有關的規劃申請編號 The application no. to which the comment relates

4/1-DB/2

**Comments on the submission in support of section 12A Application Number Y/I-DB/2 to amend Discovery Bay Outline Zoning Plan for rezoning the permissible use from staff quarters to flats at Area 6f, Discovery Bay (the Application).**

**Figure A - Map illustrating proximity of existing Parkvale Village including Village Retained Areas and Village Passageways.**

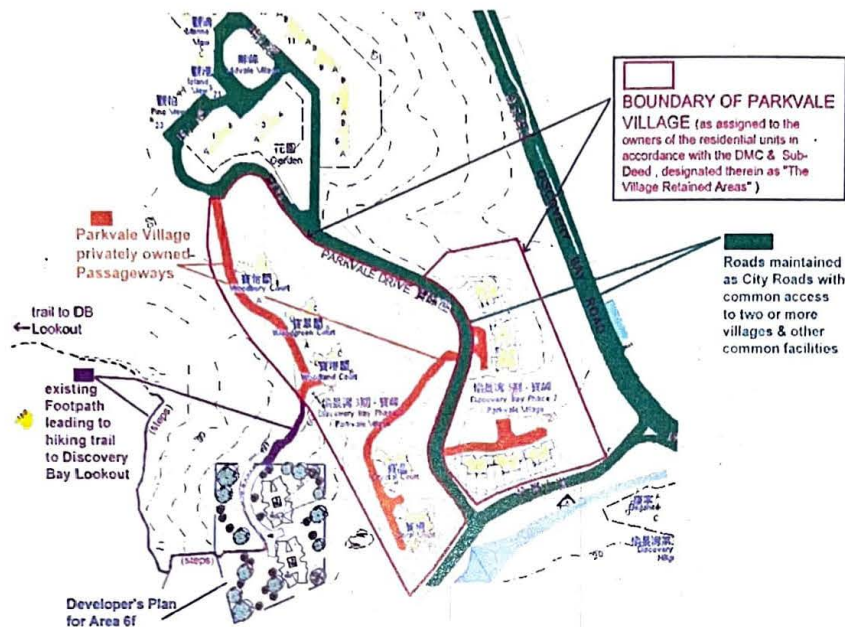
Parkvale Village is located in the Area 6b referred to in the judicial review judgements. As owners in this village we will be directly affected by the development proposed by HKR in Area 6f, as the only access proposed to Area 6f is through our village. All construction traffic and materials and, subsequent to completion of construction, all the population of the

proposed development and deliveries thereto must pass through our village. This is illustrated in Figure A below.

We are very concerned that the PlanD has indicated that there is adequate infrastructure provision to cater for the proposed development as it appears that in arriving at this conclusion the PlanD has not adequately assessed the infrastructure immediately beyond the boundaries of Area 6f, being that provided by our village on which the proposed development would have to rely.

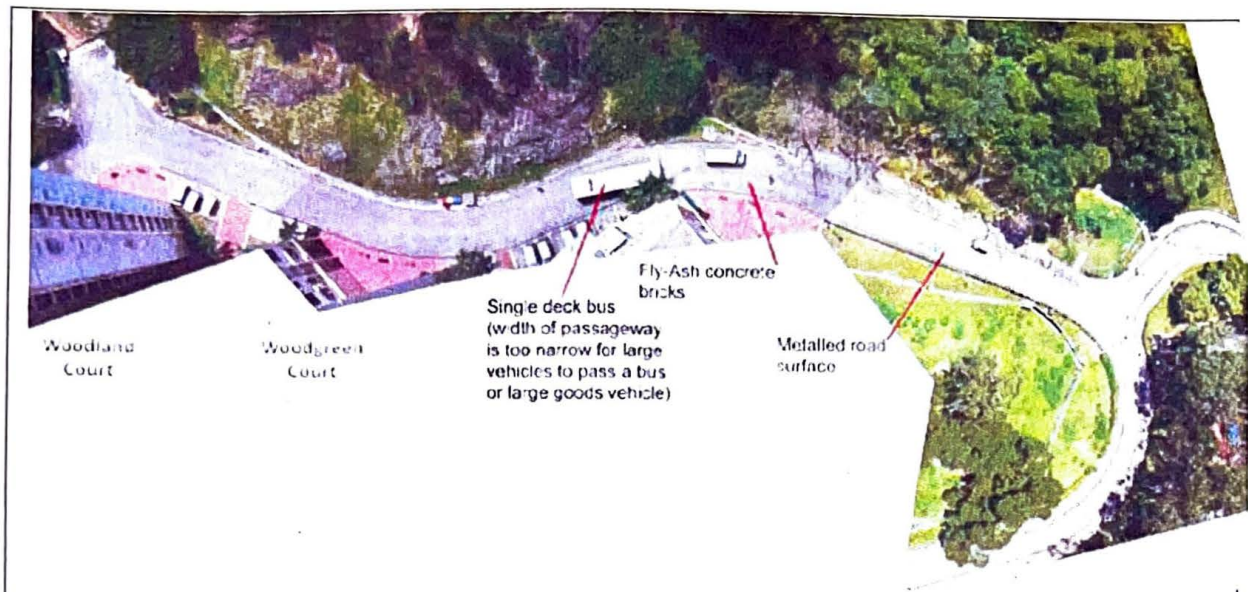
In particular we do not understand how the PlanD considers the access though our village to be adequate infrastructure. The photographs below and later clearly indicate that it is not. All traffic would have to pass along this narrow brick surfaced Passageway to enter Area 6f as its entrance is at the far end of the Passageway. To provide road access would require a new Woods Passageway and slopes.

*Section 3 of  
Parkvale Drive –  
“The Passageway”.*

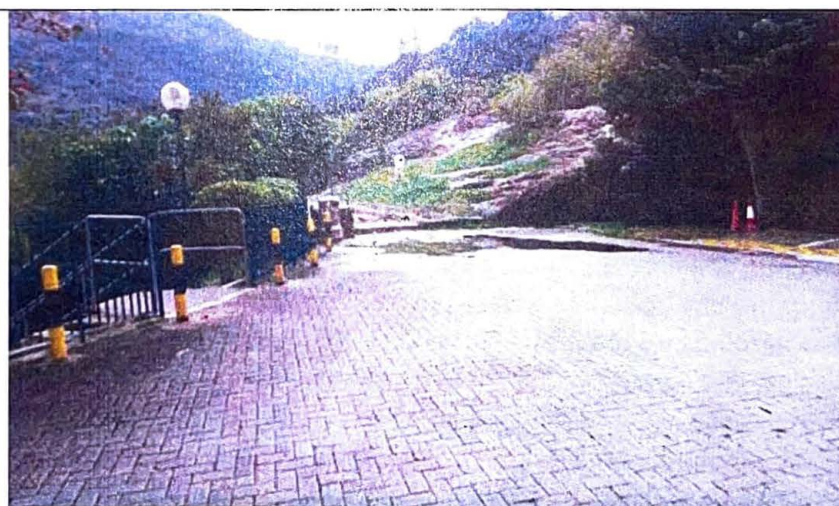
The following photographs show that the Parkvale Passageway is a pedestrianised paved area providing access and recreational space for the approximately 630 residents of the Woods area and is wholly unsuitable for through traffic and heavy traffic flow and poses a very real risk of residents, including children and the elderly, being hurt or killed by the heavy traffic.

*The far end of the  
pedestrian  
pavement is from  
where the  
proposed access  
road to Area 6f will  
start.*

The private Parkvale Drive “Passageway” design did not envisage the introduction of through traffic, especially heavy construction vehicles and increased numbers of buses, the presence of which would destroy the safety and amenity of Parkvale Village.

*Section 3 of Parkvale Drive – "The Passageway".*

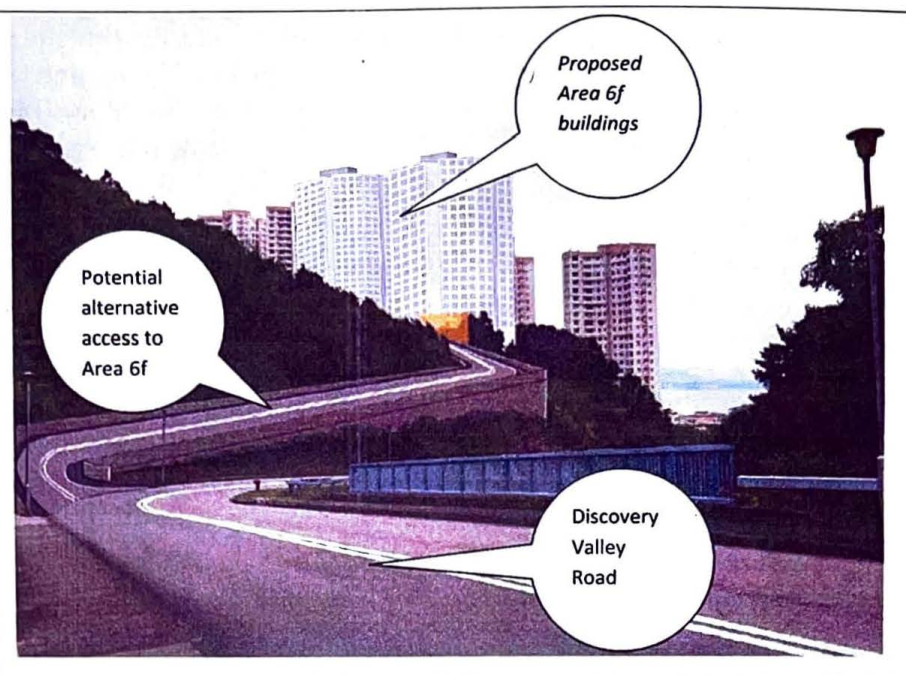
The EVA connection will involve rock breaking / slope stabilisation work adjacent to the three Woods high rise residential buildings. The existing Parkvale Drive and the "Passageway" at the three Woods high rise residential buildings are patently insufficient to properly or safely serve the construction of and the additional development when occupied by 476 Flats of 2.5 or 2.8 persons per flat. The existing three Woods high rise residential buildings are within five metres of the existing Passageway, which is also the pedestrian access way to the entrances of the 3 buildings. Consequently, the proposed EVA will not comply with the requirements of the relevant Code of Practice issued and administered by the Buildings Department unless the Passageway is widened so that there is at least five meters between Woodbury Court and the resulting access. This will require the removal of the slope currently opposite the building.

*View of the rear of Woodbury Court, illustrating the narrowness of the pedestrian pavement, its lack of a carriageway to separate vehicles from pedestrians and the inability of vehicles to pass one another.*

<p>Proposed location of sewage discharge</p>	<p><i>Picture of the redevelopment of the Discovery Bay bus station published by HKR with the location of the sewage discharge outlet added.</i></p>
---	--

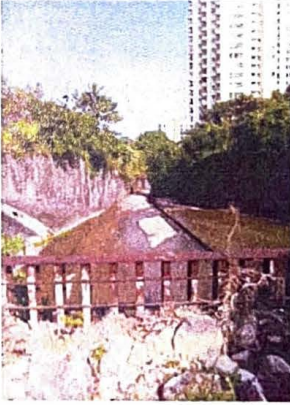
HKR proposes to provide an on-site sewage treatment plant (STP), in the basement and ground floor of the proposed buildings, to serve the proposed development as the Director of Environmental Protection (DEP) has stated that the Siu Ho Wan Sewage Treatment Works (SHWSTW), which currently treats all sewage from Discovery Bay, has no spare capacity to cater for sewage arising from the proposed development. Furthermore the Applicant proposes to:

1. Discharge the treated sewage directly into the sea next to the ferry pier using either a gravity pipe or the open nullah, which is adjacent to Hillgrove Village. However, it is clear from HKR's comments that the latter is the intended approach.

2. In the event of the STP breaking down, divert the treated sewage to the SHWSTW, despite the DEP stating that the SHWSTW does not have the capacity to receive the sewage from the proposed development.
3. Provide a larger deodorizing unit. This is an interesting response, as it clearly acknowledges that there will be an odour issue for adjacent residents and the many users of the local hiking trail. The topography and the enclosed nature of the site, surrounded by the tower blocks, means that there is likely to be issues with wind tunnelling, confined airflow and possible micro-climate conditions. No study to this effect has been carried out.

*Section 3 of  
Parkvale Drive –  
"The Passageway".*

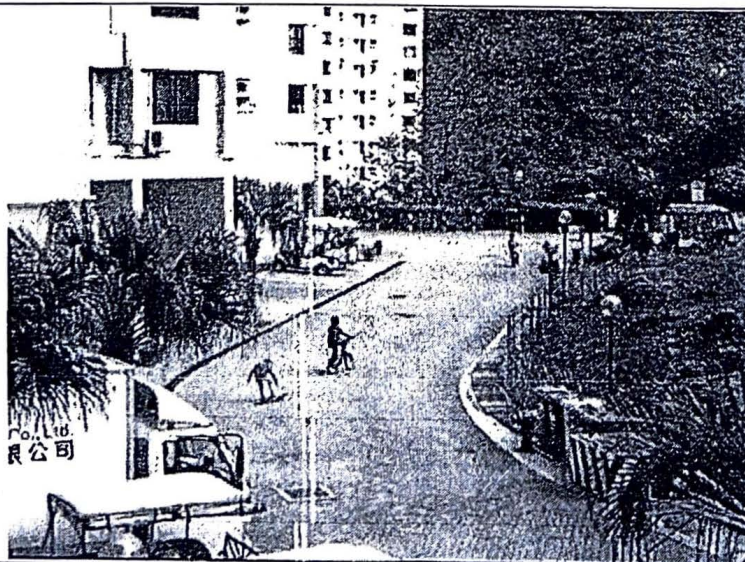
The following photographs show that the Parkvale Passageway is a pedestrianised paved area providing access and recreational space for the approximately 630 residents of the Woods area and is wholly unsuitable for through traffic and heavy traffic flow and poses a very real risk of residents, including children and the elderly, being hurt or killed by the heavy traffic.

*The far end of the  
pedestrian  
pavement is from  
where the  
proposed access  
road to Area 6f will  
start.*

The private Parkvale Drive "Passageway" design did not envisage the introduction of through traffic, especially heavy construction vehicles and increased numbers of buses, the presence of which would destroy the safety and amenity of Parkvale Village.

*Section 3 of Parkvale Drive – "The Passageway".*

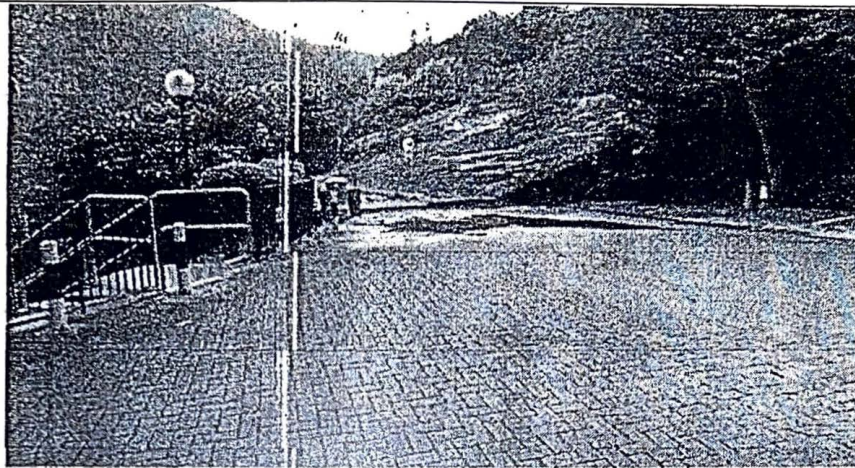
*Settlement evident to 20 tonne rated paving resulting from current traffic loading at start of the proposed access road to Area 6f.*

Apart from the inadequacy of single access via Parkvale Drive and the Woods Passageway, the Application has nowhere recognized that Area 6f will house almost double the population of the existing three Woods residential buildings, thereby trebling the residential population relying on access through the constricted Parkvale Drive private Passageway with the obvious impact on the requirement for public transport and services and the frequency of emergency calls. Blockage of this private Passageway, either by an accident by two large vehicles in conflict or collapse or washout of the narrow slope below Woodbury Court, would sever access both general and in emergencies to a significant population, which is an unrealistic proposition from a safety and amenity perspective and is socially unacceptable.

***Section 3 of Parkvale Drive – "The Passageway".***

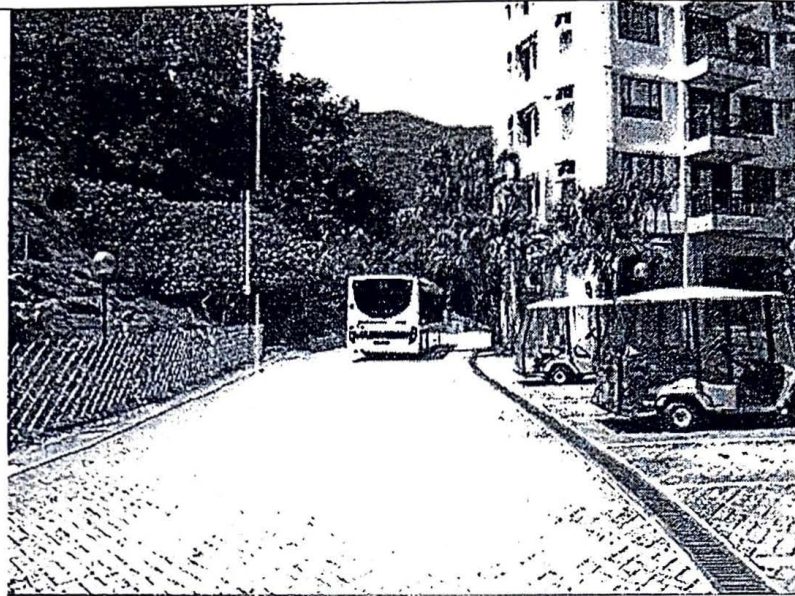
relevant Code of Practice issued and administered by the Buildings Department unless the Passageway is widened so that there is at least five meters between Woodbury Court and the resulting access. This will require the removal of the slope currently opposite the building.

***View of the rear of Woodbury Court, illustrating the narrowness of the pedestrian pavement, its lack of a carriageway to separate vehicles from pedestrians and the inability of vehicles to pass one another.***

*Potential alternative access to Area 6f from Discovery Valley Road. The existing Parkvale Village high rise buildings is in the background and the existing Discovery Valley Road is in the foreground, with the proposed Area 6f development and alternative access superimposed.*

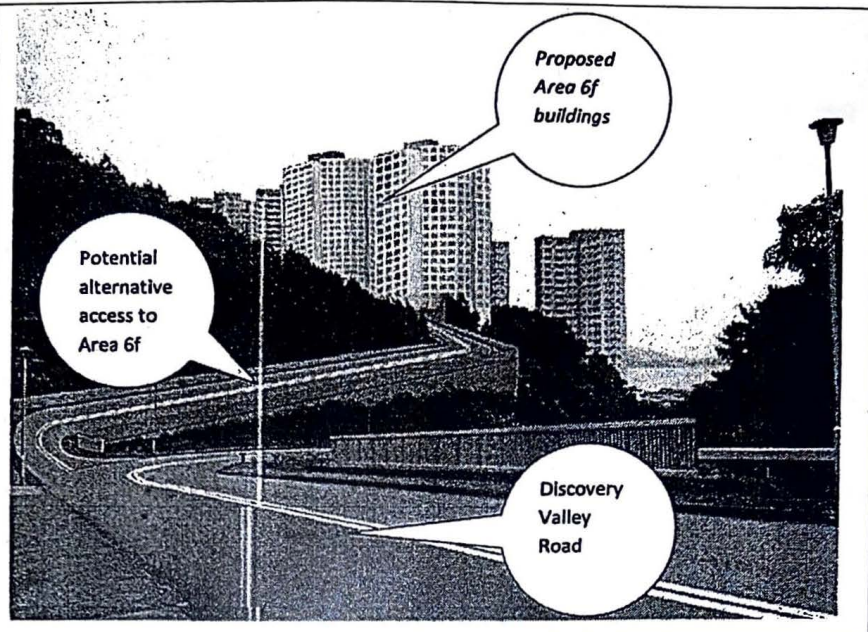
As illustrated below, an alternative potential access route to Area 6f does exist to the northwest by heading in the opposite direction away from the Woods enclave and connecting higher up to Discovery Valley Road towards the reservoir. This could possibly remove access problems through Parkvale village. Furthermore, HKR has previously stated "We (the Applicant) are aware of the potential traffic impact on the neighbourhood. As such, HKR is favourably considering to build either a temporary or permanent haul road from Discovery Valley Road." However, HKR has never mentioned either the potential traffic impact or the possibility of an alternative access from Discovery Valley Road in its Application. HKR should explain why this issue has not been addressed.

The Highways Department and PlanD should insist that this possible access is considered in the reconsideration of the application.

Figure A - Map illustrating proximity of existing Parkvale Village including Village Retained Areas

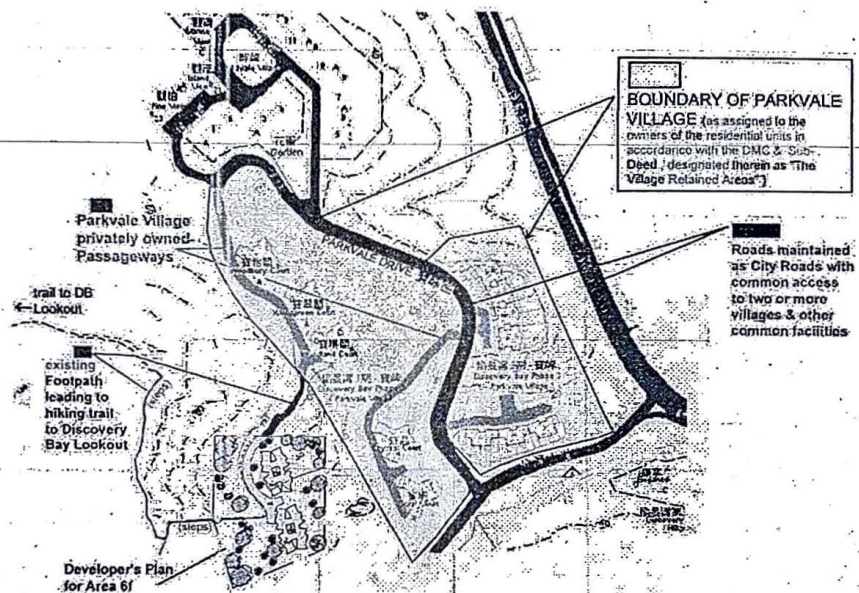
Parkvale Village is located in the Area 6b referred to in the judicial review judgements. As owners in this village we will be directly affected by the development proposed by HKR in Area 6f, as the only access proposed to Area 6f is through our village. All construction traffic and materials and, subsequent to completion of construction, all the population of the proposed development and deliveries thereto must pass through our village. This is illustrated in Figure A below.

We are very concerned that the PlanD has indicated that there is adequate infrastructure provision to cater for the proposed development as it appears that in arriving at this conclusion the PlanD has not adequately assessed the infrastructure immediately beyond the boundaries of Area 6f, being that provided by our village on which the proposed development would have to rely.

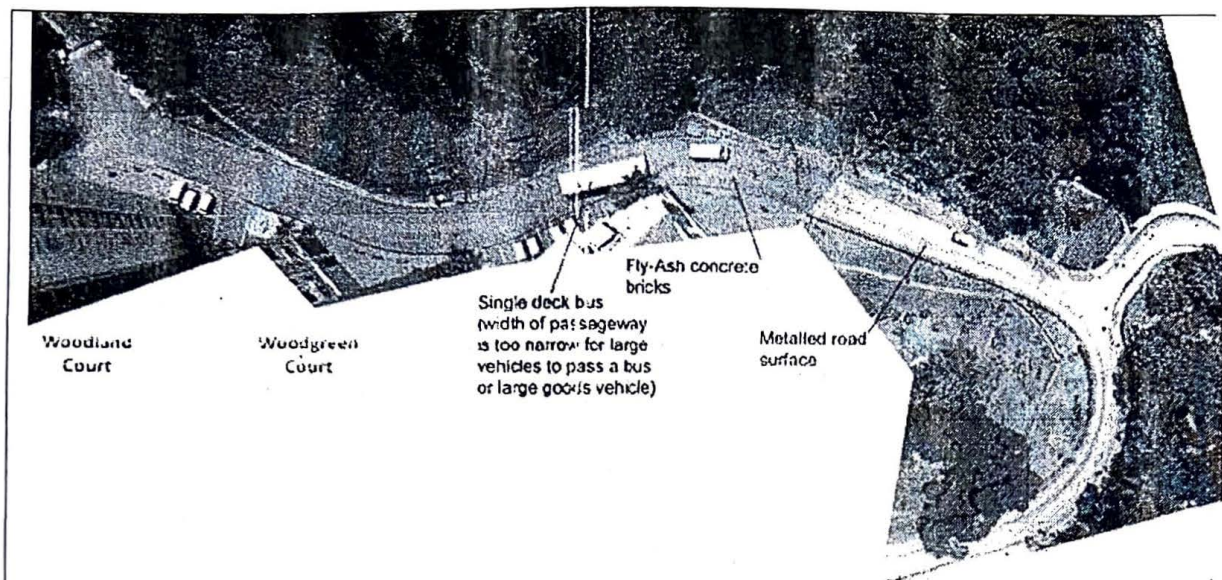
In particular we do not understand how the PlanD considers the access through our village to be adequate infrastructure. The photographs below and later clearly indicate that it is not. All traffic would have to pass along this narrow brick surfaced Passageway to enter Area 6f as its entrance is at the far end of the Passageway. To provide road access would require a new Woods Passageway and slopes.
